STATEMENT OF ENVIRONMENTAL EFFECTS

**1 - DEMOLITION OF ALL EXISTING STRUCTURES
2 – CONSTRUCTION OF PROPOSED A
TWO STOREY DWELLING WITH BASEMENT, POOL,
CABANA & SECONDARY DWELLING (ISSUED FOR
S4.55(2))**

**@ 45 Hillcrest Ave, Greenacre
NSW 2190**

1. Demolition of all Existing Structures
2. Construction of a Two storey dwelling with Basement, Pool, Cabana & Secondary Dwelling
3. **ISSUED FOR S4.55(2) – Refer to S4.55(2) Section for Information**

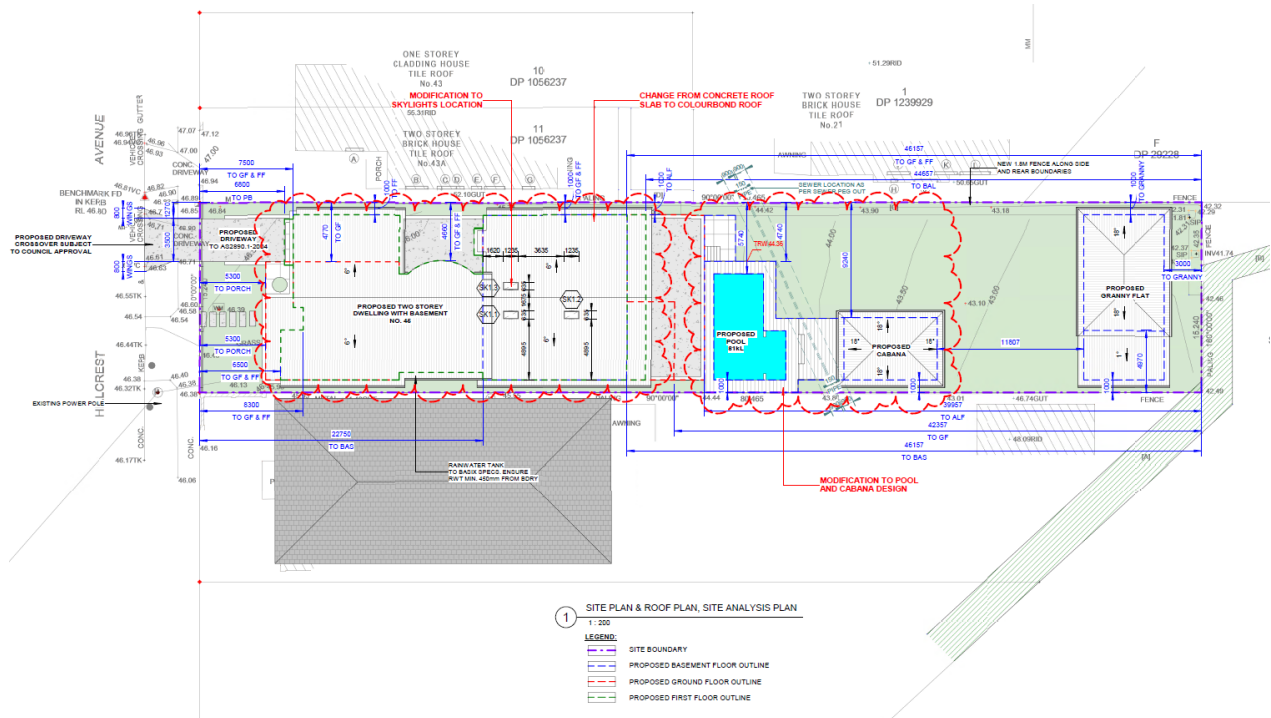
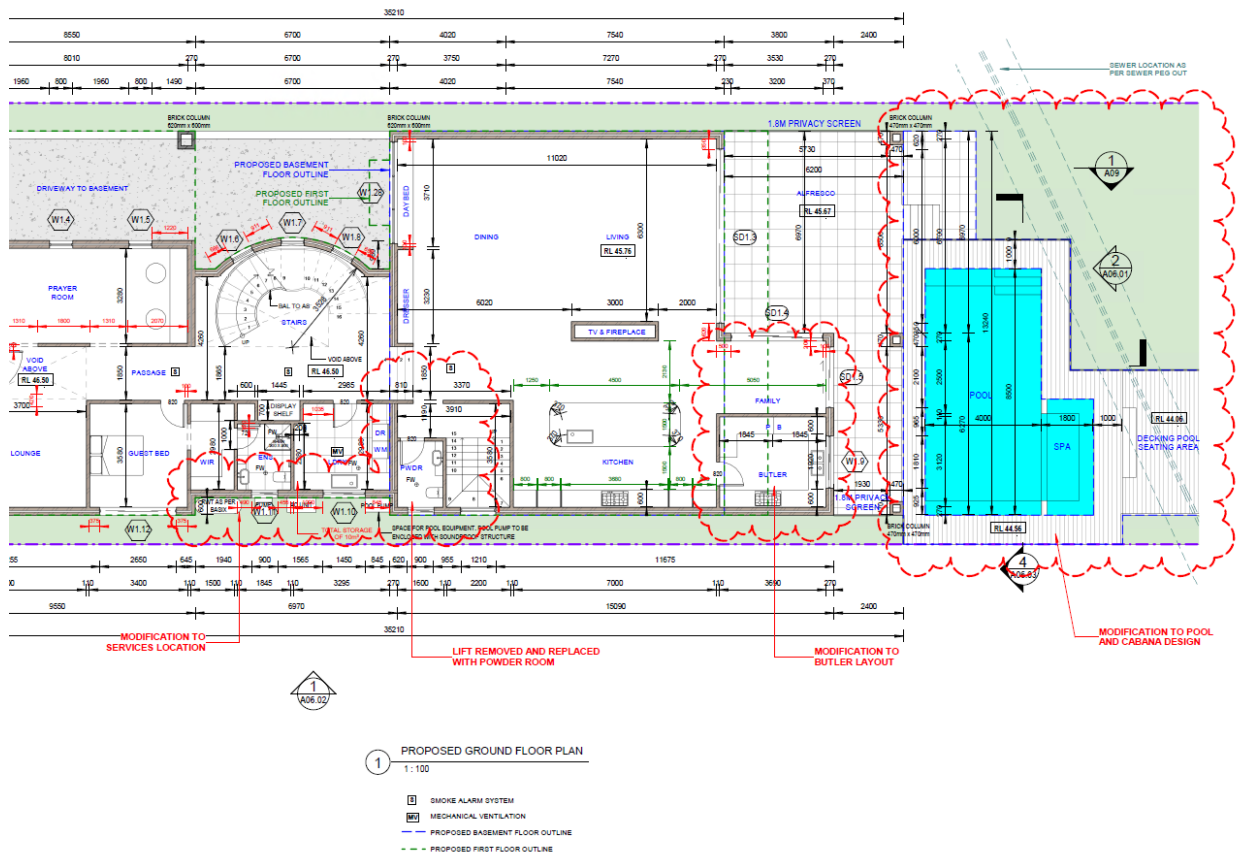
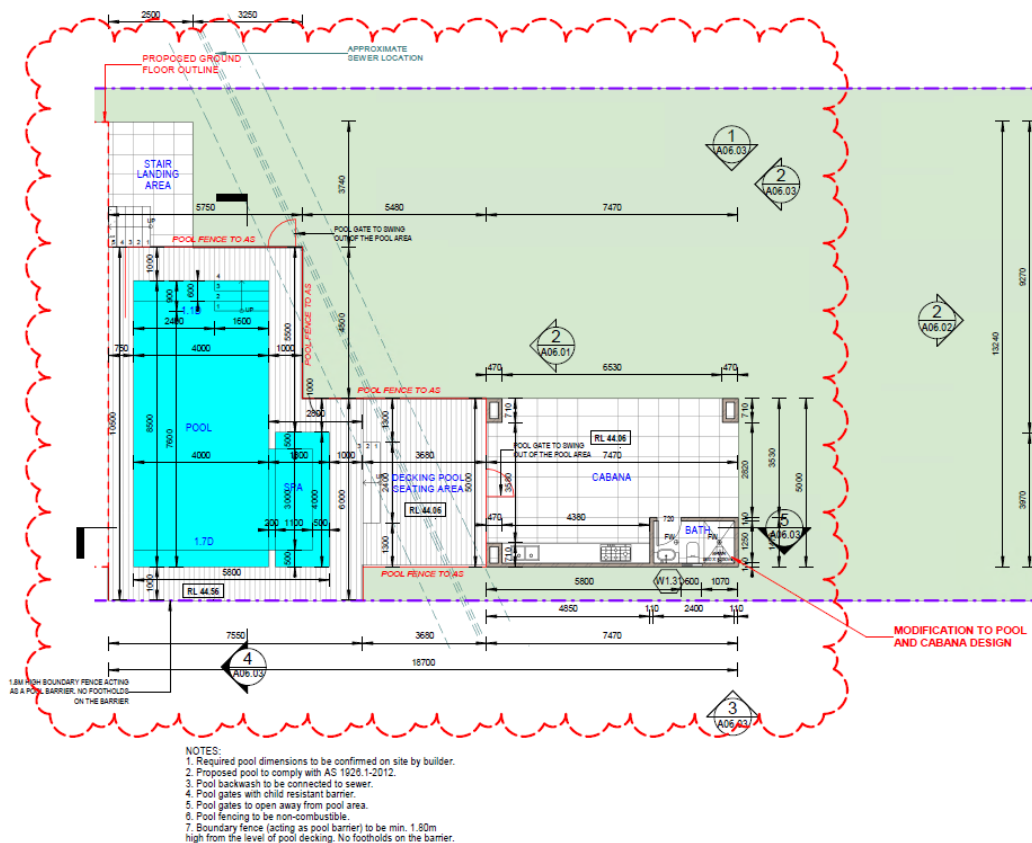
- Replace concrete roof structure with a Colorbond roof.
- Relocate Pool from underneath alfresco to backyard.
- Additional cabana placed with pool.
- Redesign back step down into backyard from alfresco.
- Removal of internal lift and slight reconfiguration to put this area towards the dwelling.
- Additional Games room placed on first floor.

Please see below images from the plans with the changes clouded.
